U.S. Department of Energy
Office of River Protection

06-ED-023

FINAL DANGEROUS AND/OR MIXED WASTE RESEARCH, DEVELOPMENT, AND
DEMONSTRATION PERMIT (RD&D Permit) FOR THE DEMONSTRATION BULK
VITRIFICATION FACILITY: REQUIRED SUBMITTAL FOR DRIED WASTE HANDLING
SYSTEM

Figure 3. Rapid Interactive Structural Analysis (RISA) Sample Output.

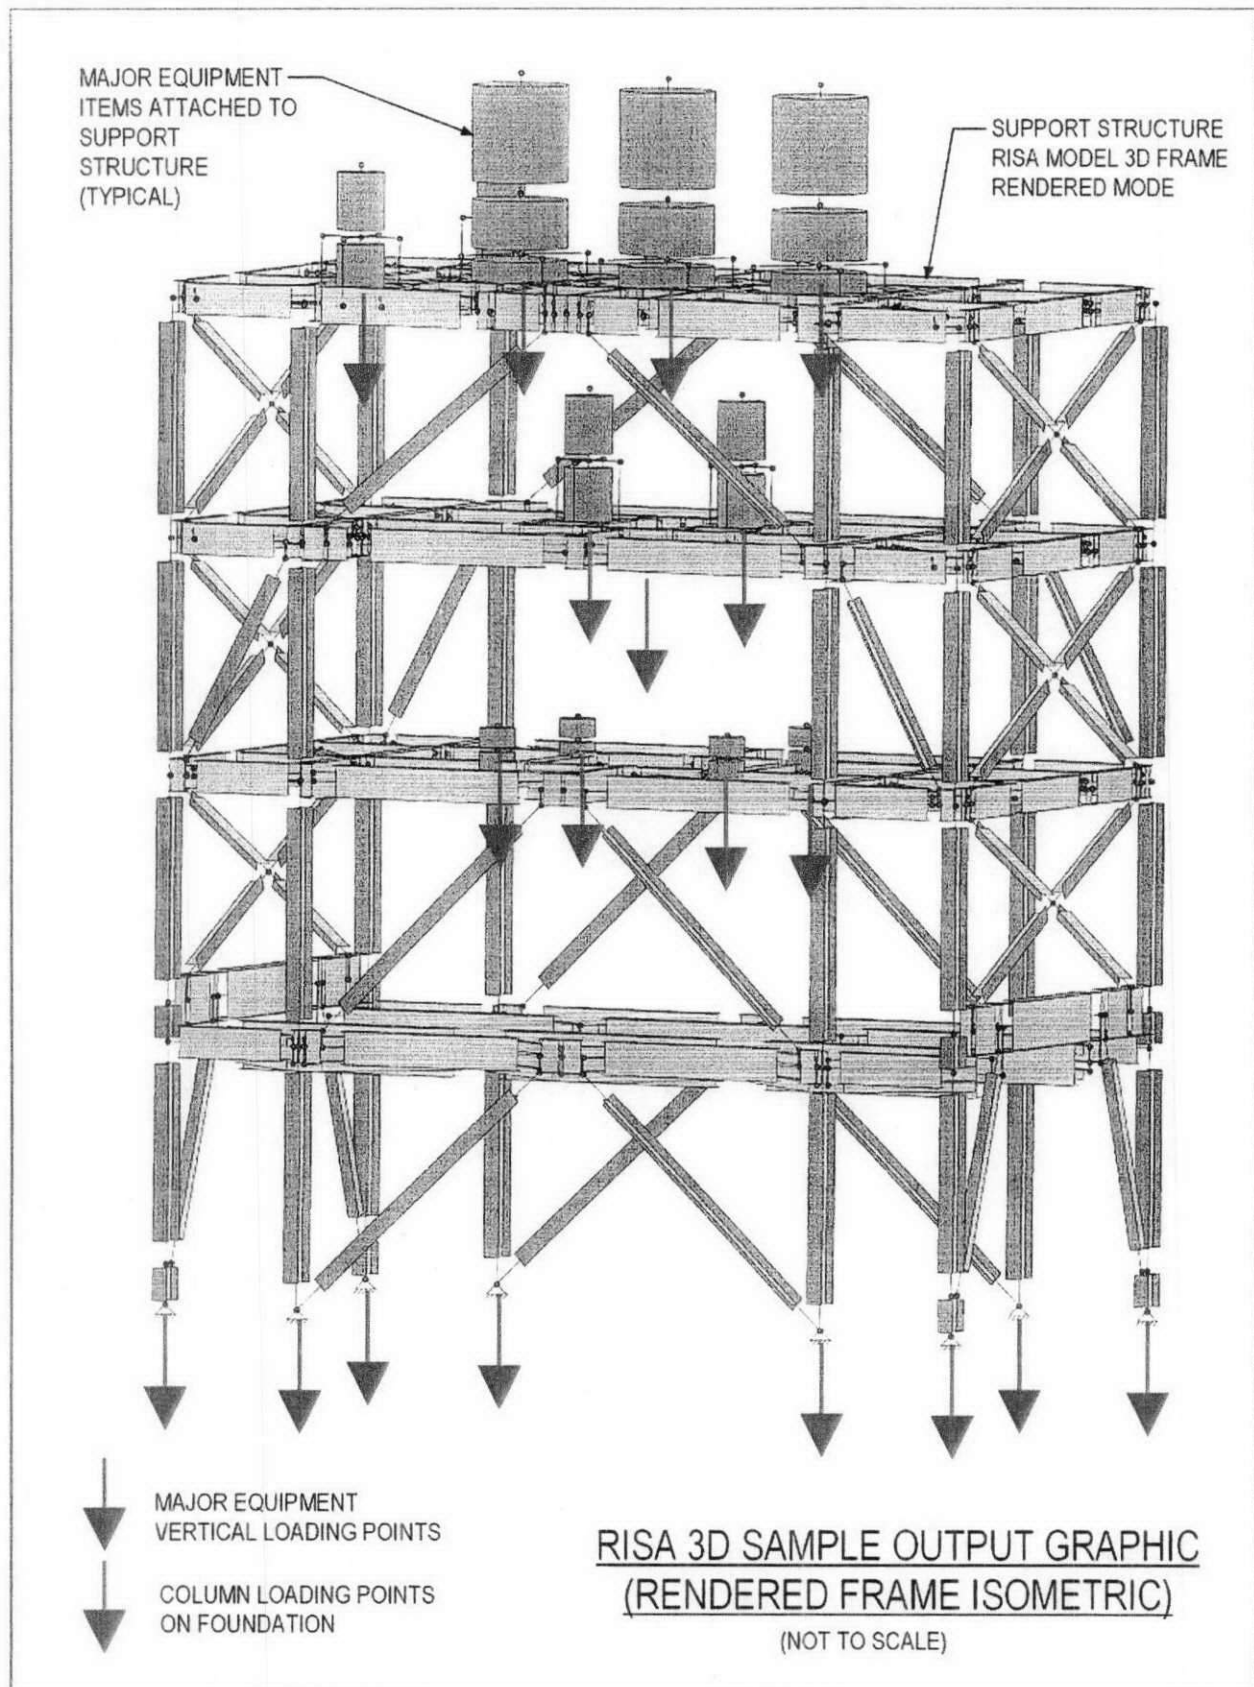
The frames at column lines Mc and Mb have no vertical bracing and rely on a horizontal truss to transfer lateral loads to column lines Md and Ma. The 97 UBC, Section 1633.2.3 requires that "Connections that resist design seismic forces shall be designed and detailed on the drawings". Horizontal bracing connections shown on AMEC drawings have sufficient detail to meet this requirement.

Figure 3 contains a RISA 3D Sample Output Graphic, which represents a simplification of actual RISA output results.

The IQRPE concludes that the appropriate structural considerations have been made.

Drawing F-145579-34-A-0101, Rev J

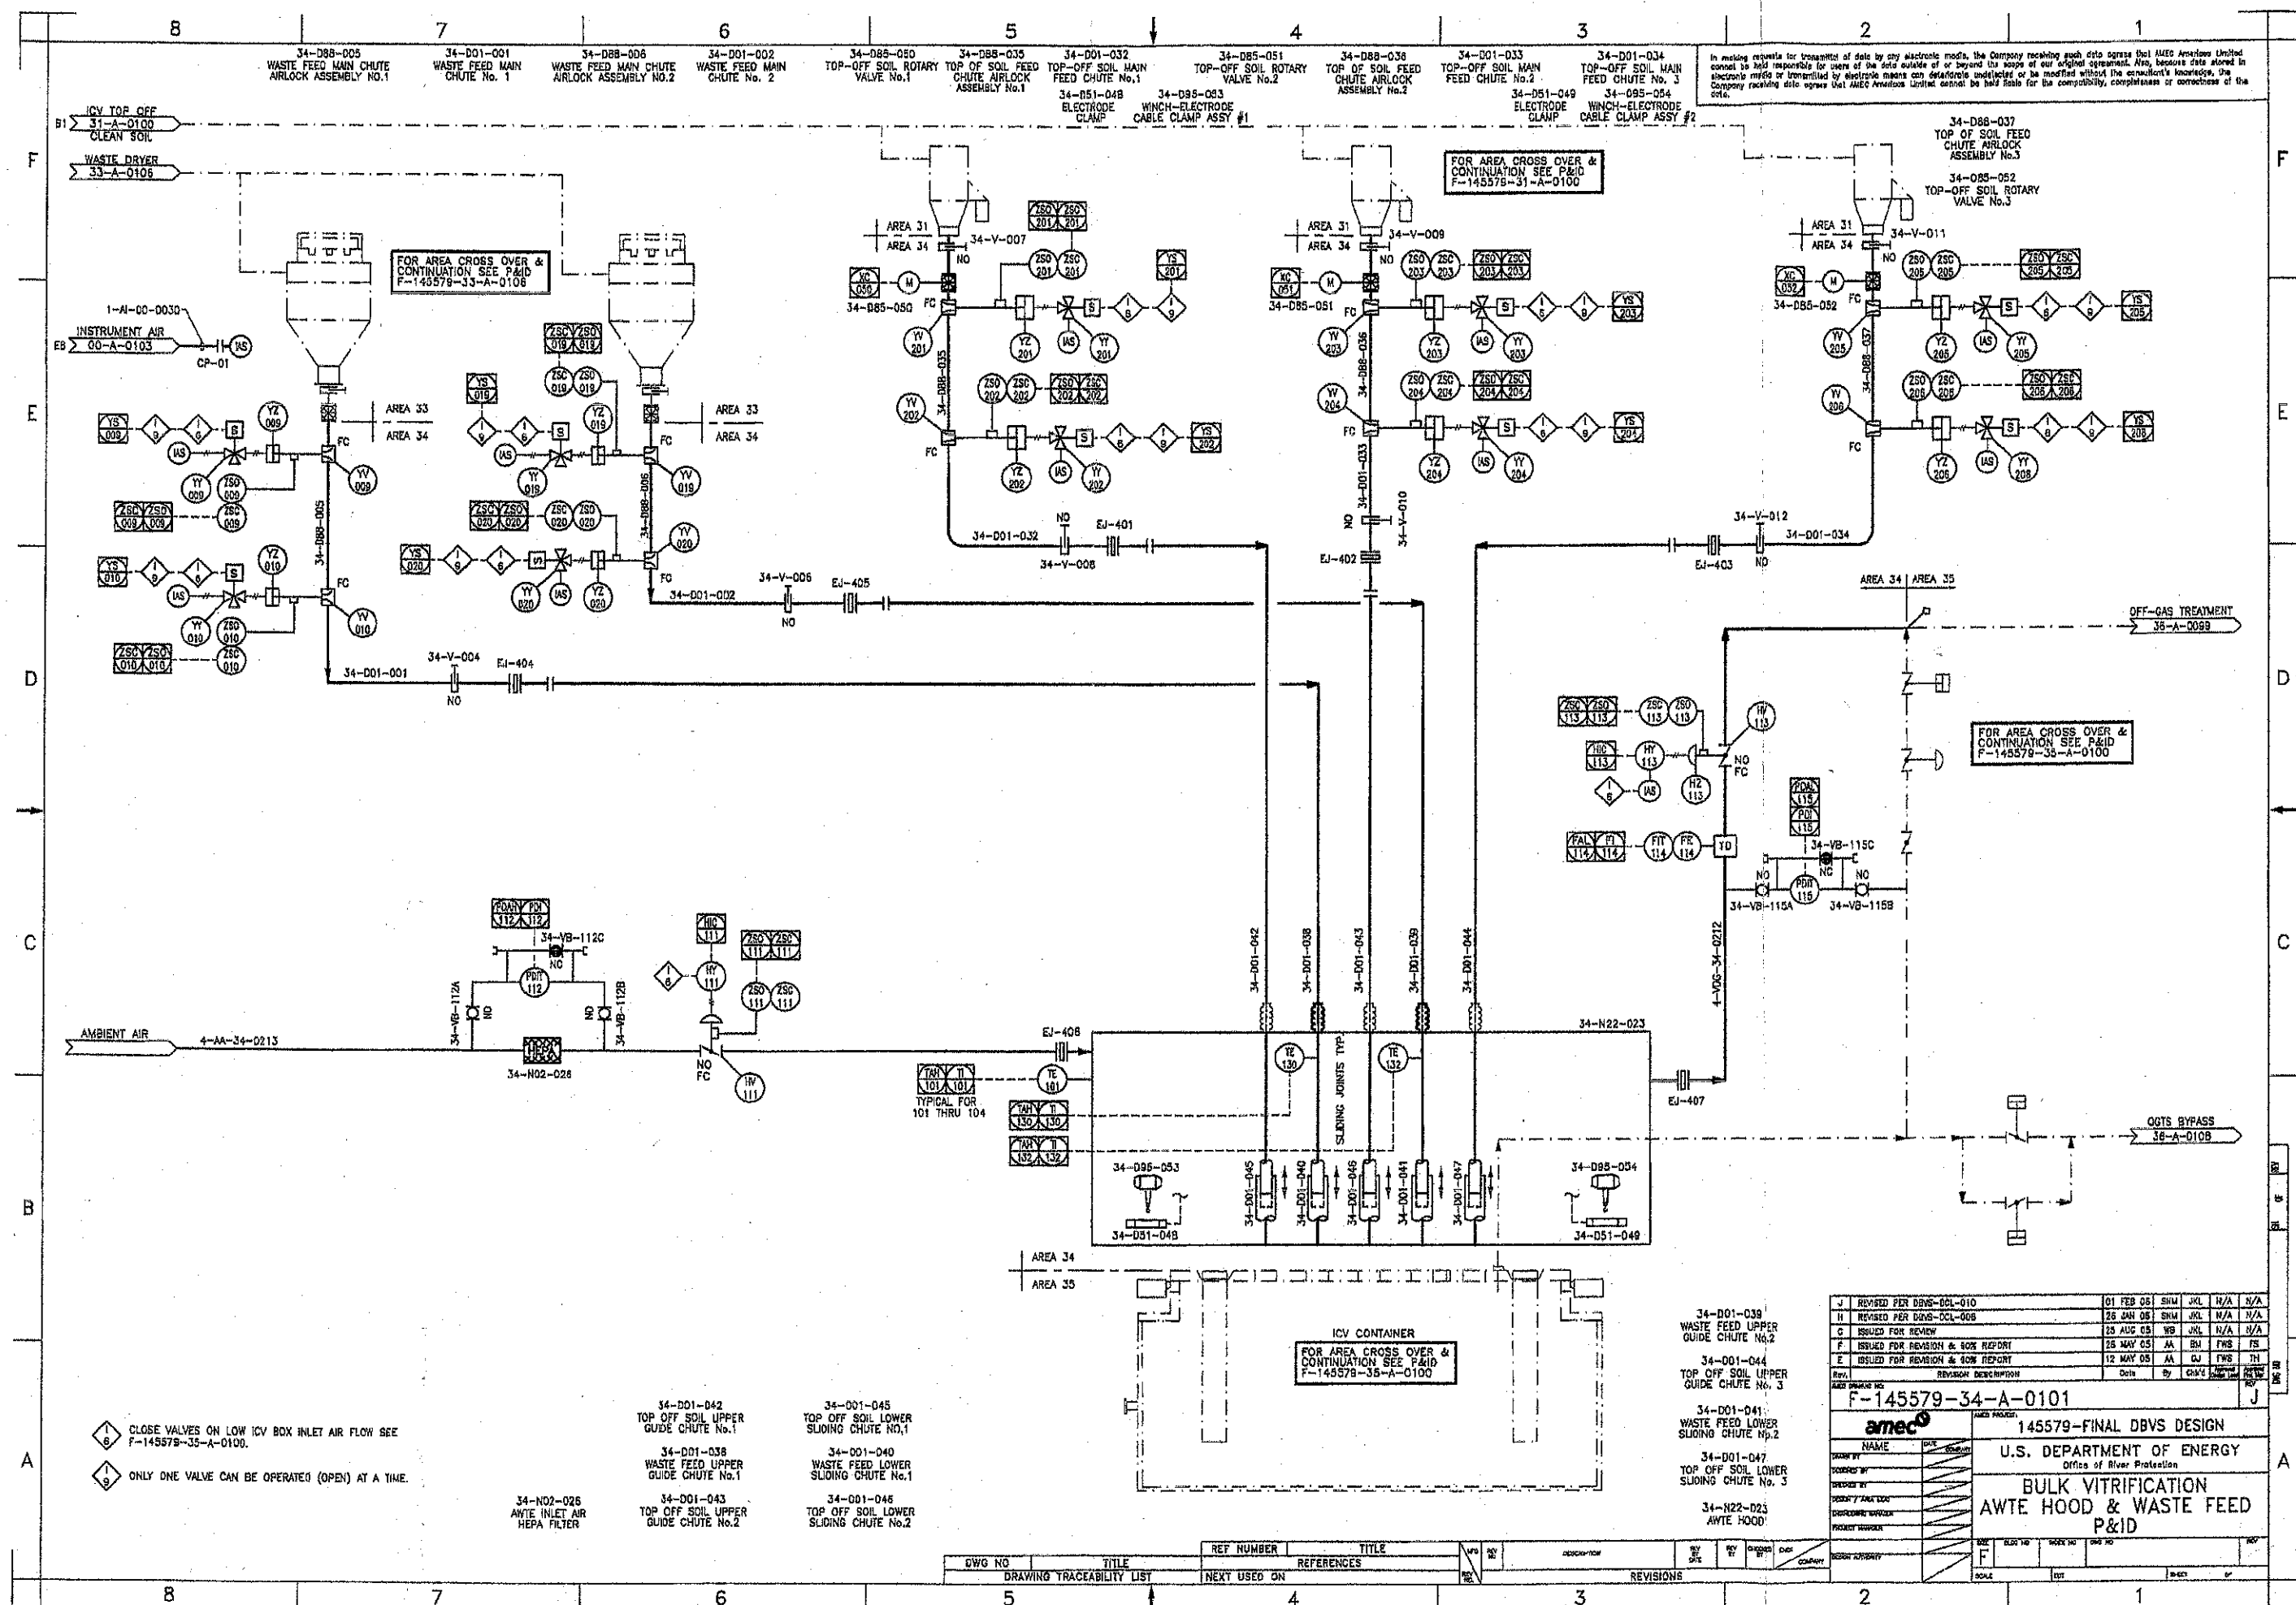
F-145579-34-A-0101 Revision J (Appendix D4)	Bulk Vitrification Waste AWTE Hood & Waste Feed P&ID	This drawing was reviewed in its entirety. Specific IQRPE review activities and any exceptions are described in Section 2.2 of this report.
Dried Waste Handling System Technical Specifications		
145579-D-DS-055.1 Revision 0 (Appendix G4)	Technical Data Sheet – Rotary Valves	This specification was reviewed in its entirety. Specific IQRPE review activities and any exceptions are described in Section 2.2 of this report.
145579-D-SP-017 Revision 3 (Appendix G4)	Specification for Ancillary Waste Transfer Enclosure (AWTE)	This specification was reviewed in its entirety, except for Appendices A (Control of Suspect/Counterfeit Items) and C (Instrumentation Naming and Tagging Convention). Specific IQRPE review activities and any exceptions are described in Section 2.2 of this report.
145579-D-SP-018 Revision 1 (Appendix G4)	Dried Waste & Top-Off Soil Airlock Assemblies	This specification was reviewed in its entirety, except for Appendix A (Control of Suspect/Counterfeit Items). Specific IQRPE review activities and any exceptions are described in Section 2.2 of this report.
